ARBORICULTURAL TECHNICAL NOTE (Updated 22.10.24)

Date: 24th March 2022
To: Tilly Whinshaw – Redrow – Head of Planning
From: Stefan Kowalczyk – RPS – Senior Arb Consultant
Pages: 8 inc. this page
Regarding: Tree Protection Fencing at Camp Field, Havant
Updated: 22 October 2024 – Ross Carthew - RPS Senior Arb Consultant

Inspection of Tree Protection Fencing at Camp Field, Havant

Figure 3. Snapshot of approved Tree Protection Plan with approximate current compound location added.

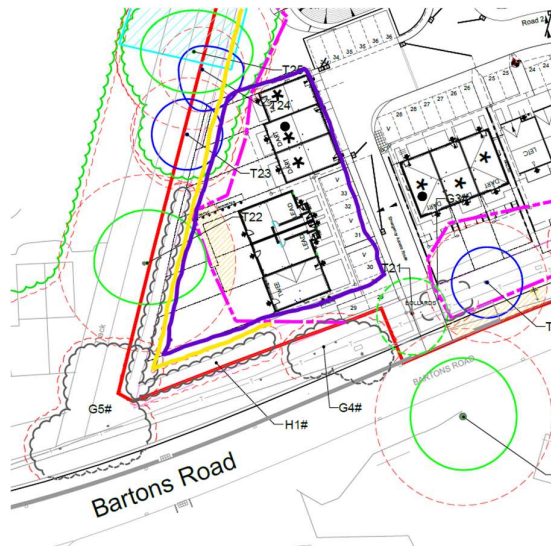
G4# and H1# is a continuation of the southern boundary tree line and is of no particular merit. T22, Oak, on the other hand is a high-quality tree with a large RPA located on the western boundary. TPF is currently positioned incorrectly and a materials storage compound has been erected in this area with “pilling mat” surfacing, a concrete slab supporting 3 mortar silos and an external wooden fence.

- 1) Yellow line represents the current location of TPF.
- 2) Pink/Magenta (dash dot) line represents the approved location of TPF.
- 3) Purple line represents the approximate extent of the existing compound.

The construction of the compound does not align with the approved TPP and any damage resulting from its development has already occurred. Fortunately, the impacted trees are situated behind an established drainage ditch, constraining potential root interference to the East and, consequently, mitigating the extent of potential damage.

Additionally, the Tree Protection Fencing running adjacent to H1# looks to be in poor condition and possibly a little closer to the trees than it should be. There is however a close board fence erected behind this which currently forms part of the compound which may be used as Tree Protective Fencing.

- 1) Notices should be placed at regular intervals, along the compounds south and west close board fencing, to denote that this fencing is to be considered Tree Protection Fencing (See examples in Appendix 1). This fencing should then remain in place until all other work are completed. The Heras fencing should also remain in situ until build is complete.
- 2) Area should be returned to soft landscaping immediately after the construction yard is removed.
- 3) Monitor the ongoing health of T22. June 2024 photograph shown below.

Figure 6. Tree Protection Plan showing trees along western boundary

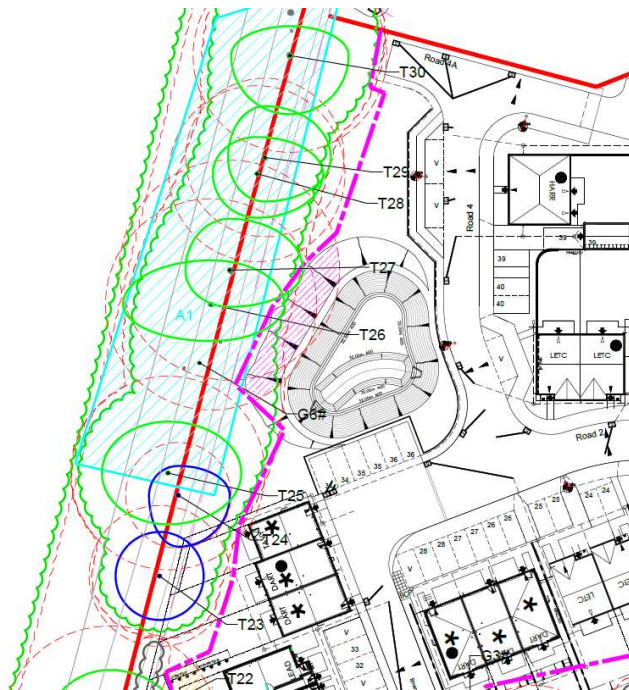
The western boundary is populated by large, mature Oak trees that are protect by a Tree Preservation Order (TPO) administered by Havant Borough Council.

TPF is currently located in an adjusted location to that found on site previously and is now nearer to the approved location as detailed on the Tree Protection Plan. The TPF broadly follows the canopy extent or 'drip line' of the mature Oak trees.

There is an existing ditch within the RPA on the eastern side of the stem which may limit shallow rooting to the east somewhat. However, given the age and stature of these trees it is highly likely that roots have occupied the land east of the existing ditch.

Stored topsoil within the RPA has been removed back to the existing fencing line. Some minor levels of spoil / sub-soil still lie inside of the newly established CEZ, however the depth and extent of these materials would not appear to be significant.

- 1) Remove remaining spoil from construction exclusion zone back to existing levels. This should be done using appropriate hand tools. Where possible, the use of machines with a long reach should be favoured, if they can work from outside of the RPA. Removal of the spoil shall occur in strips working from the undisturbed surface, working in a retreating manner away from the retained tree. No reduction in levels of the underlying soil surface shall occur with RPA's.
- 2) Once the spoil has been removed sub-soil aeration will be carried out by an approved contractor using compressed air to decompress soil. This will be done at 1 meter centres along the area previously covered with spoil.
- 3) During the decompaction process, soil amelioration will be undertaken by injecting bio char, mycorrhizal fungi and/or tree fertiliser and bacteria into the soil, along with the air.

Figure 9. Section of H1 removed highlighted in Yellow and approximate location of installed access road shown with red lines.

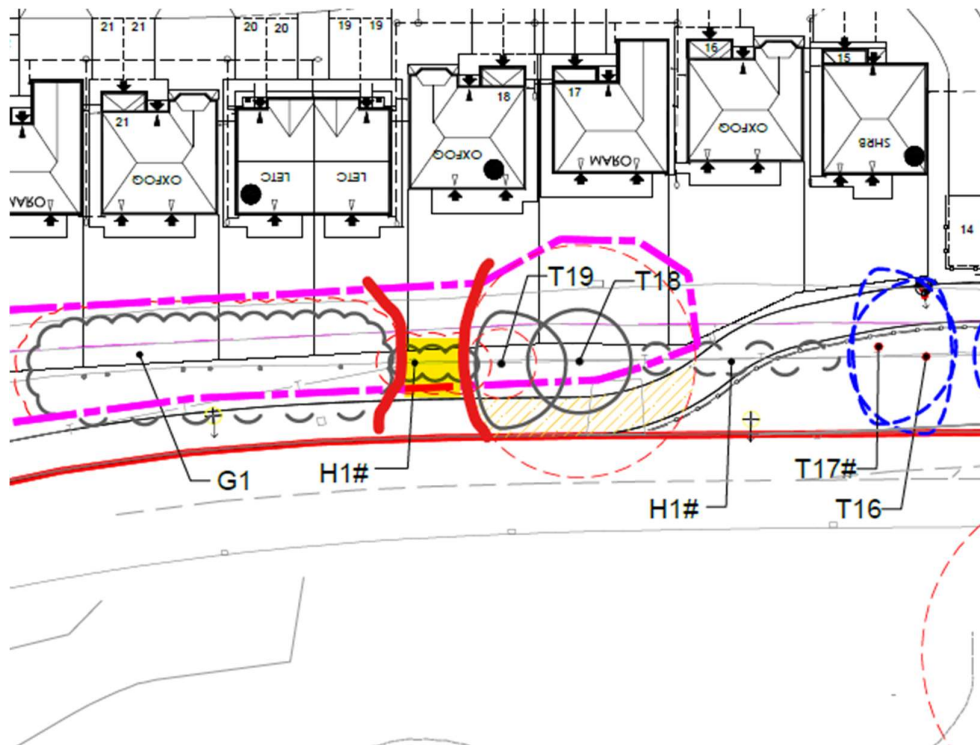
A section of H1# has been removed and an access road has been installed in its place. This detail was not included within the Tree Protection Plan however, the impact to existing trees is likely negligible. Exact impact to the east end of G1# is however unknown – tree roots could have been severed and/or negatively impacted without prior consideration due to the excavation and installation of a subbase.

TPF has not been installed in accordance with the Tree Protection Plan however, it is generally adequate for the same reason expressed within section 1.1 of this note.

Figure 11. Extract of JSL3850_715A showing revised tree protection/ removals proposed for cycle path construction.

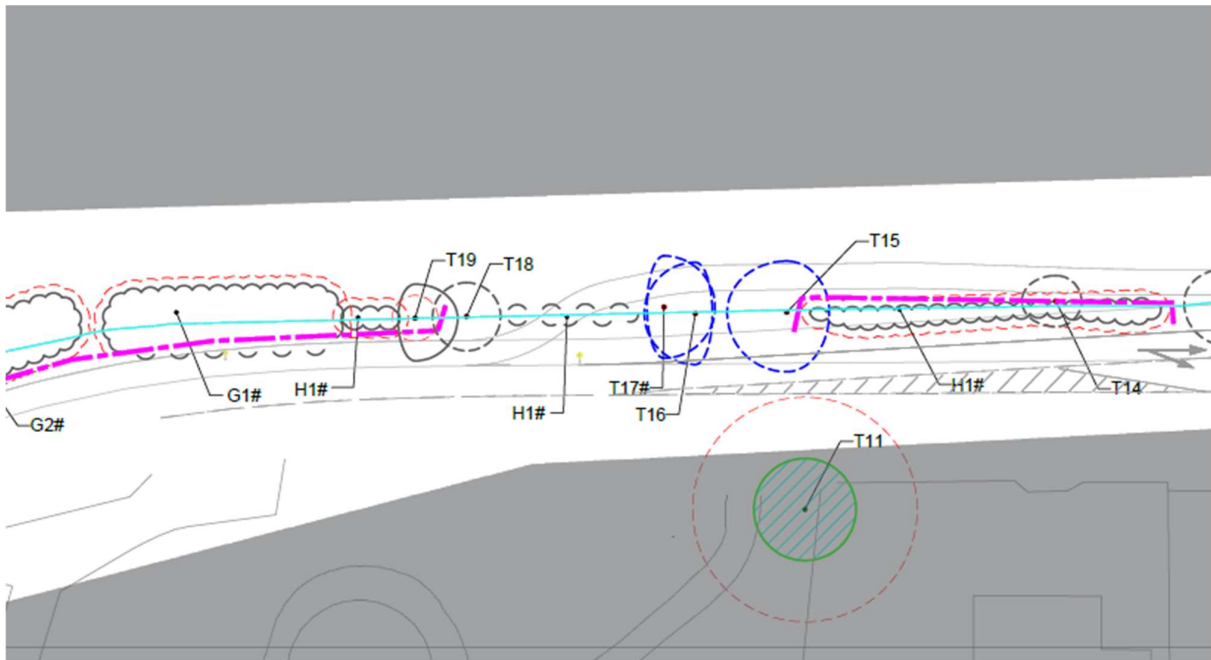
As shown in figure 9 above, Drawing JSL3850_710D & 711C shows a section of proposed “No-Dig” cycle path adjacent to T18 & T19, however, the need for this “No-Dig” has been reassessed following Utilities work carried out along Barton’s Road verge, shown below:

This work will have severed the roots of T18 & T19 back from the proposed cycle path negating the need for “No-Dig” construction, additionally T18 was highlighted for removal following the works, due to concerns over its future stability with the utility works having affected a large amount of its southern RPA, and has now been felled. These changes to the design and construction of the cycle path were picked up in a separate, cycleway specific, AIA (JSL3850_781A) and shown on its accompanying Tree Protection Plan (JSL3850_715A), as shown below:

Hedgerow H1# shown in Figure 11 above has been removed. Redrow have proposed the replanting of this hedgerow to the council and are in discussions with Highways.
